## **Stakeholder Engagement Issues and Needs Gathering – June-July 2013**

**54<sup>th</sup> Street Reconstruction  
and Arden Park Stormwater  
Management Plan**

# City of Edina: 54<sup>th</sup> Street Reconstruction and Arden Park Area Stormwater Plan Design Component Stakeholder Feedback

## 54TH ST CROSS SECTION WITH NO PARKING

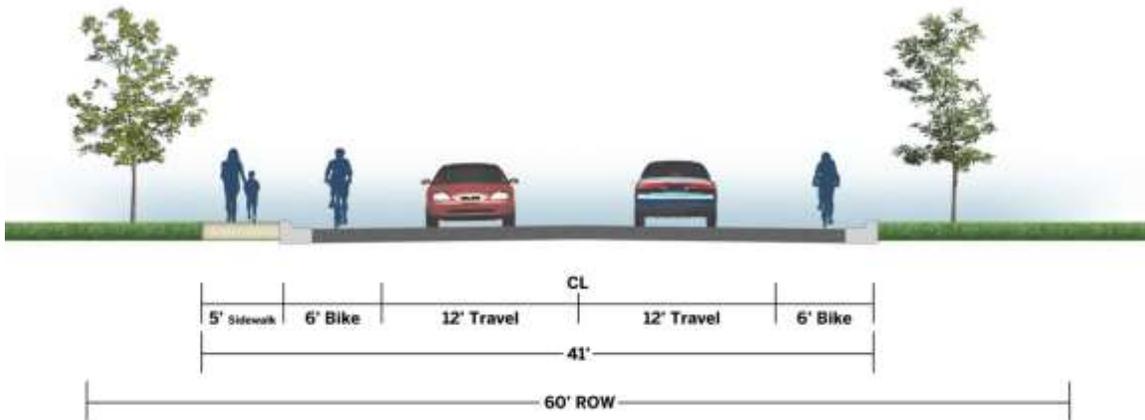
Card	Positives	Negatives
<b>7: 54TH ST CROSS SECTION WITH NO PARKING: No parking; sidewalk on both sides</b>	<ul style="list-style-type: none"> <li>• Best option, but provide parking along Brookview near 54<sup>th</sup></li> <li>• Opp.-undergrounding electric safety improvement</li> <li>• One sidewalk only</li> <li>• No parking</li> <li>• Something for cycles</li> <li>• State plows sidewalks</li> </ul>	<ul style="list-style-type: none"> <li>• One sidewalk sufficient</li> <li>• No parking</li> <li>• Two sidewalks</li> <li>• No need for two bike lanes</li> <li>• No boulevard- too large</li> <li>• Able to reroute buses</li> <li>• Too many sidewalks</li> <li>• Too much space devoted to bikes</li> <li>• No need for parking</li> <li>• Encroachment</li> <li>• Impact to residents</li> <li>• Visually too much concrete</li> <li>• Too wide</li> <li>• Infringement on property</li> <li>• No parking, and we need parking</li> <li>• Need parking. The street is the only spot for guest parking</li> <li>• No bike lanes, pedestrian safety</li> <li>• One sidewalk is enough. It takes away homeowner green space</li> <li>• Sidewalk safety going down a steep roadway, down the north side is safer</li> </ul>

## 54TH ST CROSS SECTION WITH NO PARKING

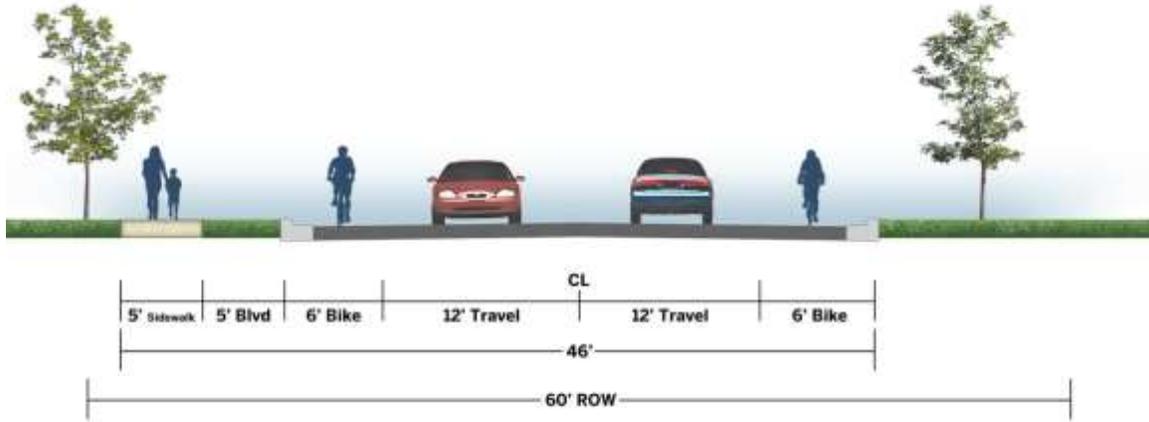
<b>10: 54TH ST CROSS SECTION WITH NO PARKING: No parking; sidewalk on one side with boulevard</b>	<ul style="list-style-type: none"> <li>• Like sidewalk with boulevard</li> <li>• Sidewalk on one side</li> <li>• Bike lane for kids</li> <li>• I like the existing treatment. Bicycle safety, speeding, water quality. Bicycle boulevards are also good if no room for lanes. Narrow auto traffic lanes can help slow traffic.</li> <li>• Sidewalk on 2 sides and 0 parking lanes. I've never seen cars parked in this area, so no parking lane needed.</li> <li>• Sidewalks on 2 sides and 1 parking lane.</li> <li>• Sidewalk on 1 side and 0 parking lanes</li> <li>• sidewalk on one side and 0 parking lanes</li> <li>• Need a sidewalk.</li> <li>• sidewalk on 2 sides and 1 parking lane</li> <li>• sidewalk on 1 side and 0 parking lanes</li> <li>• Sidewalk on one side, no boulevard, 0 parking lanes</li> <li>• Love the sidewalk</li> <li>• Sidewalk on 1 side and 2 parking lanes. I believe the corridor narrows from the creek to Wooddale Ave.</li> <li>• No positive</li> <li>• sidewalk on 2 sides and 0 parking lanes</li> <li>• Sidewalk on one side and zero parking lanes. Everyone affected as parking in front of residences on the Avenues.</li> <li>• Need a sidewalk for residents and pedestrians. Would like one parking lane and NO BIKE LANES. Share the Road is sufficient!!!</li> <li>• People should be able to walk to park without getting on the street,</li> <li>• sidewalk on one side and no parking lanes separate pedestrians from traffic is good idea parking lanes not needed never see anybody parking along here anyway</li> <li>• Sidewalk on 2 sides, no parking lane. Too much traffic goes through that intersection to have parking.</li> </ul>	<ul style="list-style-type: none"> <li>• No parking for the church or neighbors</li> <li>• Don't want 10 ft of my yard (person lives on 54<sup>th</sup>)</li> <li>• No parking</li> <li>• Boulevard</li> <li>• No boulevard</li> <li>• No dedicated bike lanes</li> <li>• Need parking on one side only</li> <li>• Bike lanes</li> <li>• Boulevard</li> <li>• No parking</li> <li>• Let's not let auto parking wishes from no longer decrease a lower quality of life and environment. Water and air quality are very important.</li> <li>• Those residents bordering 54th don't need parking on 54! They already have parking in front of their homes.</li> <li>• Do not observe demand for parking in that area. Don't need more than one sidewalk</li> <li>• for safety street has to be as wide as possible a few cut-outs could be used</li> <li>• the street is hilly and site lines are bad. Parking will make it worse for neighbors to cross over 54th street. As it is, many cars come zooming up the street and do not see crossers until they get close to them. Especially when the sun is low in the sky.</li> <li>• Need a sidewalk on at least one side. Neighbors and visitors need to have available parking on at least one side.</li> <li>• Need parking</li> <li>• no particular need for parking on this portion, significant benefit from sidewalk on both sides</li> <li>• I certainly don't want more of my lawn eaten up for impervious surfaces.</li> </ul>

## ADJUST 54TH ST VERTICAL GEOMETRY

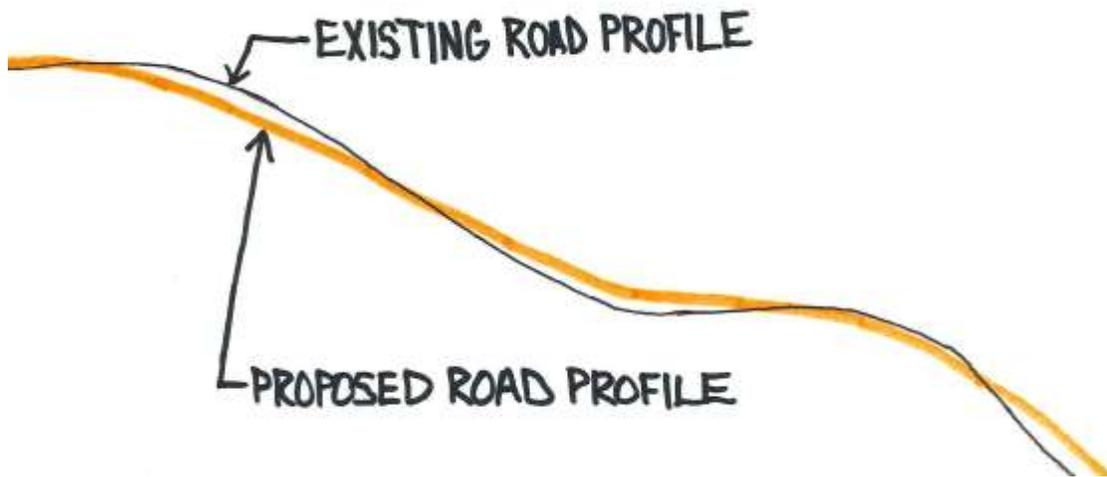
Card	Positives	Negatives
<b>11: ADJUST 54TH ST VERTICAL GEOMETRY: Raise the vertical elevation of 54th St near the bridge</b>	<ul style="list-style-type: none"> <li>• Like it because it decreases the slope, slows down traffic, and can help with snow and winter condition</li> <li>• Helps with speed east of Brookview</li> <li>• Decreases speed for stop sign</li> <li>• May decrease speed</li> <li>• Raise grade from church to Brookview</li> <li>• Helps with Park Place intersection</li> <li>• Better to go underneath bridge</li> <li>• See cars sooner</li> <li>• Change profile if safety increase (i.e. ice and snow) decreases speeding. Do not if this would increase water runoff</li> <li>• Grading at 54<sup>th</sup> and Park Place</li> <li>• Raise elevation of bridge</li> </ul>	<ul style="list-style-type: none"> <li>• Impact on the low side (N. side of 54<sup>th</sup> St.)</li> <li>• Takes away the charm, want the area to feel country</li> <li>• Difficult</li> <li>• Cuts into property</li> <li>• Property value</li> <li>• Cost for small change?</li> <li>• Encroachment</li> <li>• Questions about speed</li> <li>• Under construction from Wooddale to Brookview</li> </ul>

## CURB EXTENSION

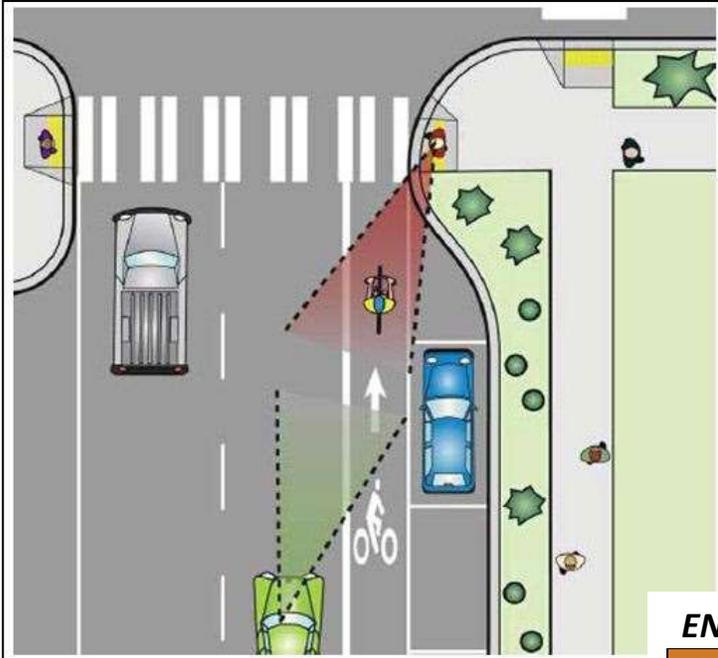
<p><b>15: CURB EXTENSION: Shorten pedestrian crossing, improve sight distance, and provide parking bays</b></p>	<ul style="list-style-type: none"> <li>• Like it</li> <li>• Love making the intersection about the pedestrian, less about the car</li> <li>• Good idea to slow traffic</li> <li>• Could use at Park Place too</li> <li>• Subliminal traffic control</li> <li>• I would like to see this at all Edina intersections, where feasible</li> <li>• Pedestrians have a clearly defined walk area</li> <li>• takes away less green space</li> <li>• ok</li> <li>• Parking</li> <li>• Seems reasonable.</li> <li>• moving parking back from crossing w/bays improves visibility of pedestrians</li> <li>• Good visibility for pedestrian</li> <li>• Excellent. Safety and Plants more trees</li> <li>• shorter pedestrian crossing</li> <li>• Much thought given to all users</li> <li>• Good for pedestrians</li> <li>• Can see it east of Minnehaha where there is parking</li> <li>• Less distance for pedestrians to cross the road</li> <li>• Parking is good</li> <li>• Seems to address safety issues.</li> <li>• I like the parking bays</li> <li>• may slow down traffic</li> <li>• Sidewalk is drawn here--that is more important than curb extension</li> <li>• Dedicated bike lane</li> <li>• better sight lines</li> </ul>	<ul style="list-style-type: none"> <li>• Doesn't help with church parking—no go</li> <li>• Negative</li> <li>• Don't want to do this IF it moves stop signs</li> <li>• No bump outs for parking – unnecessary</li> <li>• The bike lane is not protected and runs next to parked cars.</li> <li>• This can be accomplished without shortening cross walk--no need</li> <li>• car could hit biker at bridge</li> <li>• Too much property taken for boulevard.</li> <li>• Does not fit into the look of our neighborhood</li> <li>• Encroaches on my property, removes trees</li> <li>• Sorry but I don't know where this example applies. One way street? Looks nice though.</li> <li>• still potential for accidents between bikes and parked cars</li> <li>• I need a parking bay on 54th Street by my house like I need a hole in the head.</li> <li>• Not sure where these would be located. If on 54th, I propose making the road SMALLER by no designated bike lanes and single lane markings on the road.</li> <li>• East ward bike access?</li> <li>• Don't like the sidewalk on 54th. Don't like the bike lane. The road looks way to wide</li> <li>• Is the road wide enough to accommodate the extension and bike lanes and cars?</li> <li>• Does this mean there will be sidewalks on 54th, that is the priority</li> <li>• Do not want a boulevard or parking</li> <li>• Reduces property value</li> <li>• This "plan," if I may be so generous to call it that, will just increase speed on 54th.</li> </ul>

<ul style="list-style-type: none"> <li>• Pedestrians separated from traffic</li> <li>• Reduces crossing distance, insets parking spaces, provides additional boulevard for planting</li> <li>• "pinch point" would seem likely to slow cars</li> <li>• Curbs are good</li> <li>• Appears aesthetically pleasing which is important.</li> </ul>	
<p><b>17: 5-FT GUTTER PAN BICYCLE LANE:</b> Bicycle lane is distinguished by concrete with no longitudinal gutter seam to negotiate</p>	<ul style="list-style-type: none"> <li>• Good width for bike lane</li> <li>• More noticeable</li> <li>• Hardcore bicyclists use bike lanes</li> </ul>	<ul style="list-style-type: none"> <li>• Concern about upkeep long-term</li> <li>• Bikers do not like potholes</li> <li>• Differences in aging properties</li> <li>• No thanks, need parking (church member)</li> <li>• Loss of parking</li> <li>• Bumpy to ride on</li> <li>• Kids don't use bike lanes</li> <li>• Concrete is expensive</li> <li>• Do not need separation</li> </ul>

## ZEBRA OR CONTINENTAL CROSSWALK

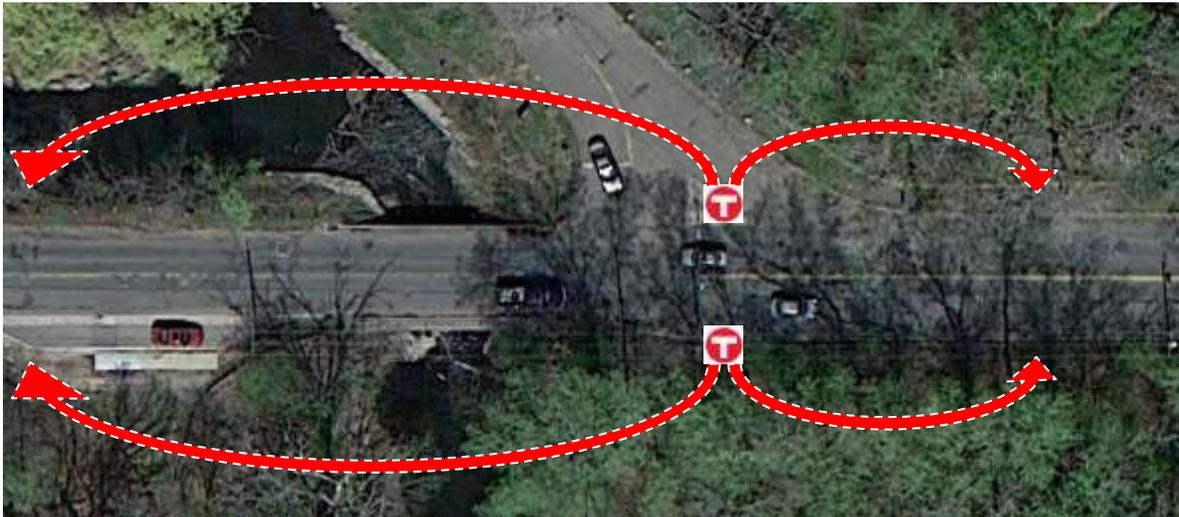
<p><b>22: ZEBRA OR CONTINENTAL CROSSWALK: Highly visible pavement marking design option indicating heavily crossed area</b></p>	<ul style="list-style-type: none"> <li>• Can avoid slippery white stripes</li> <li>• Best option out of the two</li> <li>• Prefer this option to Card 26</li> <li>• Greater visibility</li> <li>• Safety</li> <li>• Caution</li> <li>• Be aware</li> <li>• Florescent crosswalks</li> </ul>	<ul style="list-style-type: none"> <li>• Somewhat garish looks</li> <li>• Not a fan of the design</li> <li>• Less aesthetically pleasing</li> <li>• Safety with the hill grade</li> <li>• Do not belong on side streets</li> </ul>

Provide waiting area for transit users

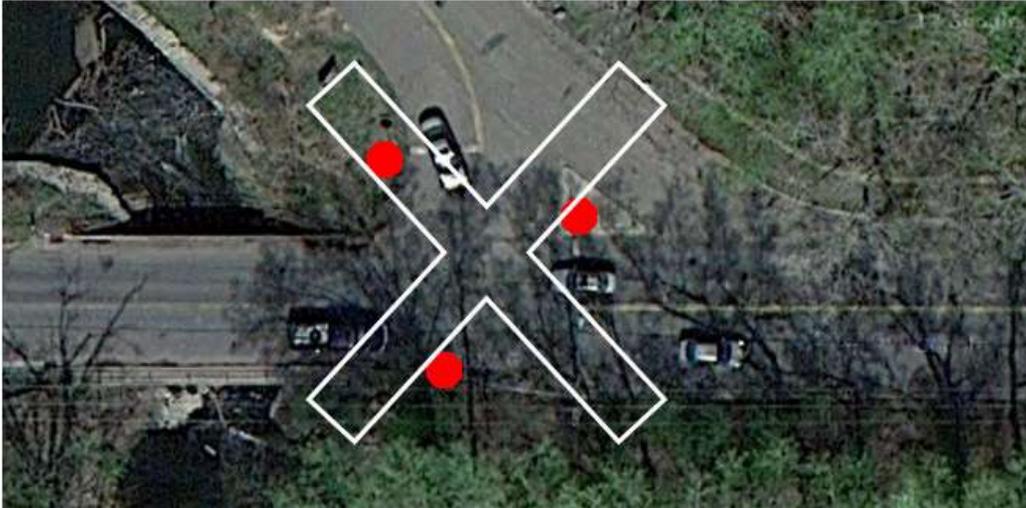
<b>29: CONCRETE BUS STOP PAD: Provide waiting area for transit users</b>	<ul style="list-style-type: none"> <li>Like place for kids</li> <li>Like it for school buses, not for public transit</li> <li>Safer for kids to wait for the bus</li> </ul>	<ul style="list-style-type: none"> <li>Not pretty, needs landscapes</li> <li>No concrete</li> <li>Keep size small</li> <li>School bus routes change; may not end up at a stop</li> <li>City isn't maintaining trees</li> <li>Fearful of giving it to the city</li> </ul>
<b>31: REPLACE ALL-WAY STOP: Explore alternatives for safe crossing and traffic calming</b>	<ul style="list-style-type: none"> <li>Stop signs slow down buses</li> <li>Paint a crosswalk on this option Cyclists prefer no stops</li> </ul>	<ul style="list-style-type: none"> <li>Need stop signs</li> <li>Keep all-way for safety – people already go too fast</li> <li>Keep stop sign at the bridge</li> <li>Keep stop signs</li> <li>Keep stops to slow drivers</li> <li>Won't fit in our neighborhood – flashy isn't the right choice near this park</li> <li>Kayaking in way and more people parking</li> <li>They need stop sign</li> </ul>
